Subject: Class II permissive change Request  
FCC ID: N4ZFT1800

Granted on: 07/24/2019

The difference between FT18 and PL18EV. PL18EV has more light panels than FT18, and some functions have been adjusted, as follows:

Original:

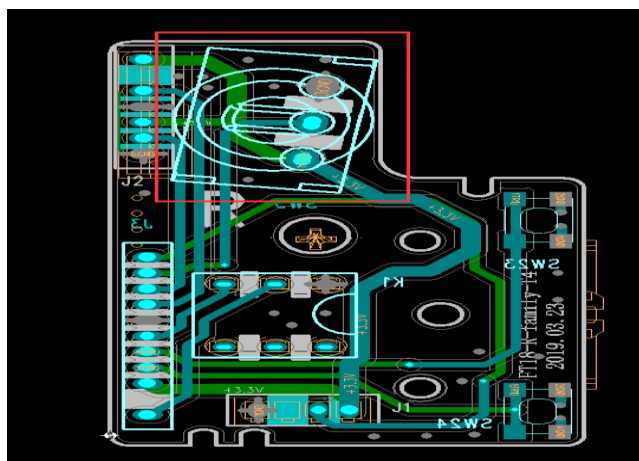
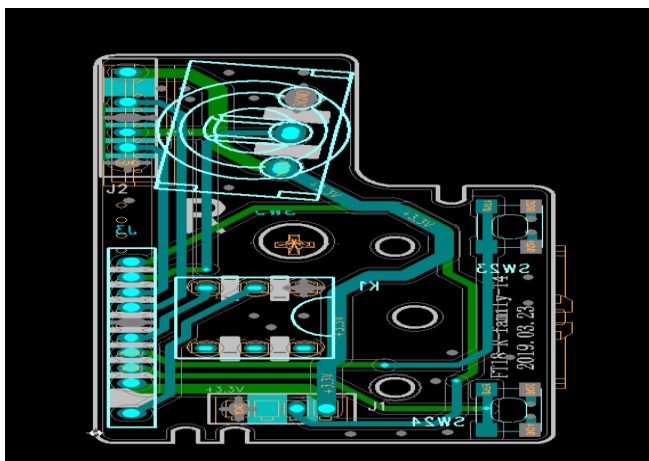
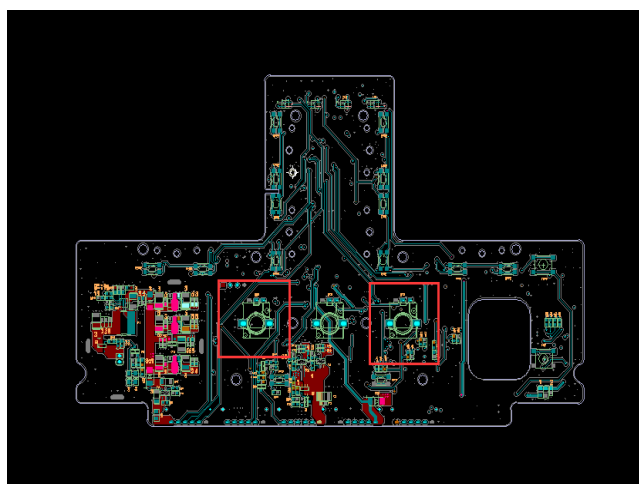
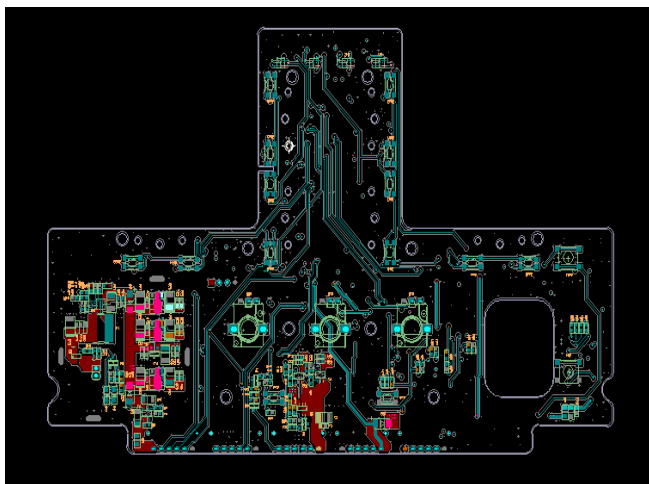
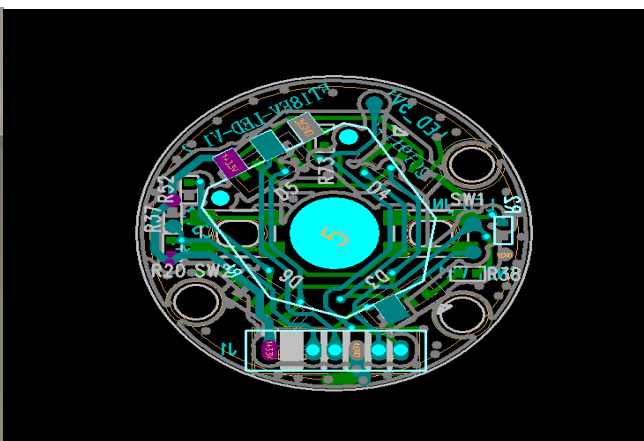
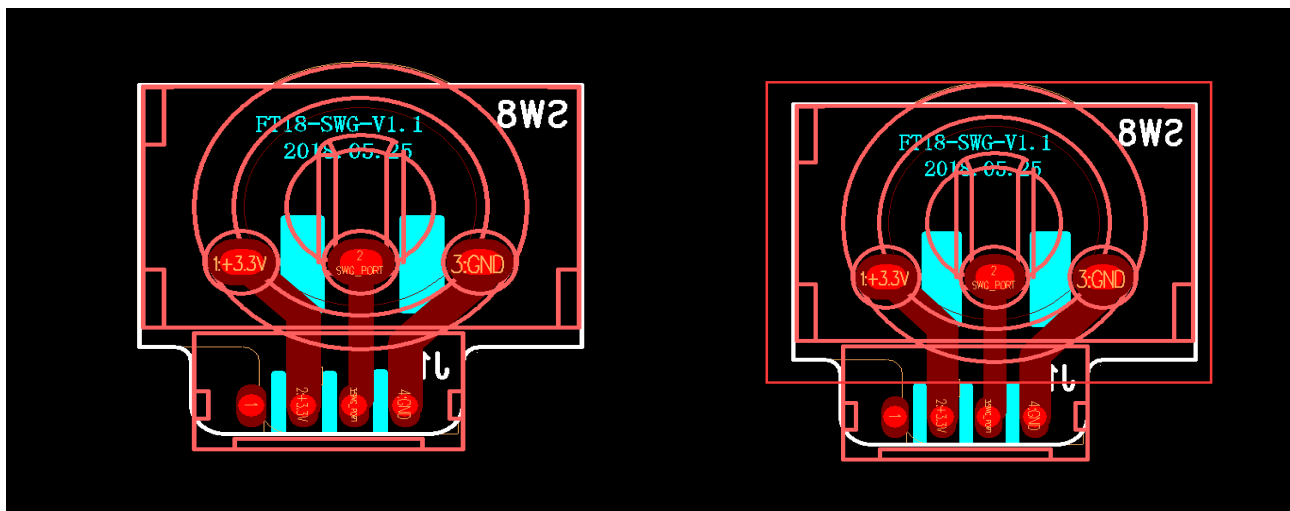
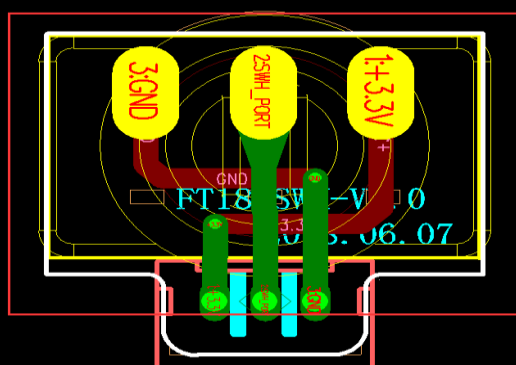
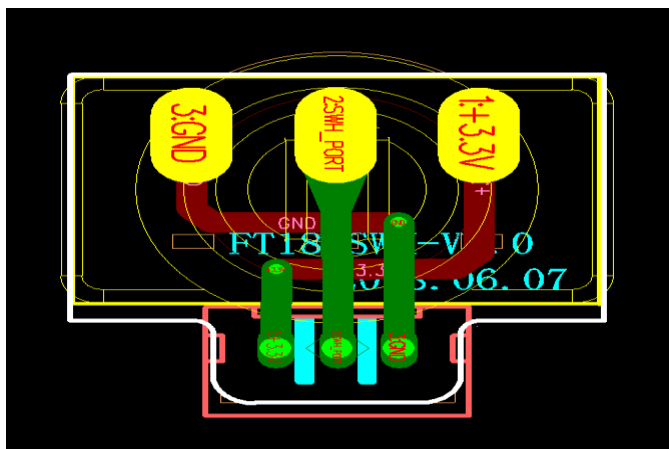
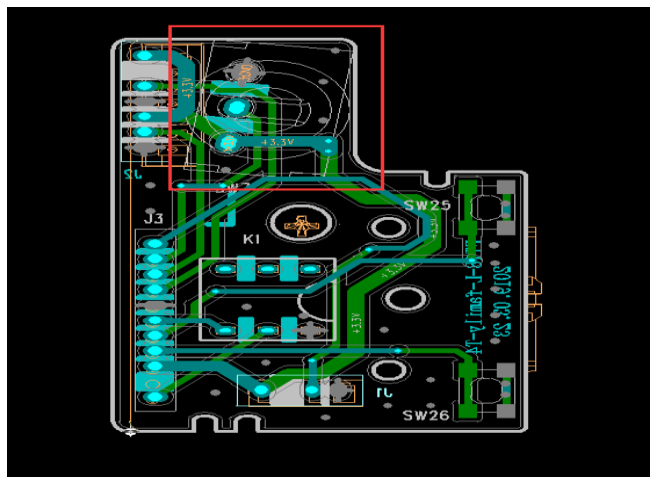
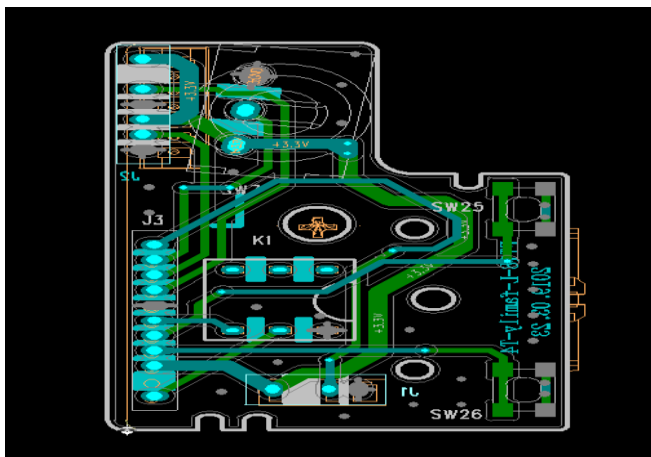
The FT18-SWH-V1.2 SWH two-gear reset switch is modified to a three-gear long-handle reset switch

The FT18-SWG-V1.2 SWG two-gear stop switch is modified to a three-gear short-handle reset switch

The FT18-R-family-T2 SWD three-gear stop switch is modified to a three-gear short-handle reset switch

The FT18-L-family-T2 SWB three-gear stop switch is modified to a three-gear short-handle reset switch

FT18- Fine-tuning -T4 VRA VRC by original BU 'Hui' ZHONG
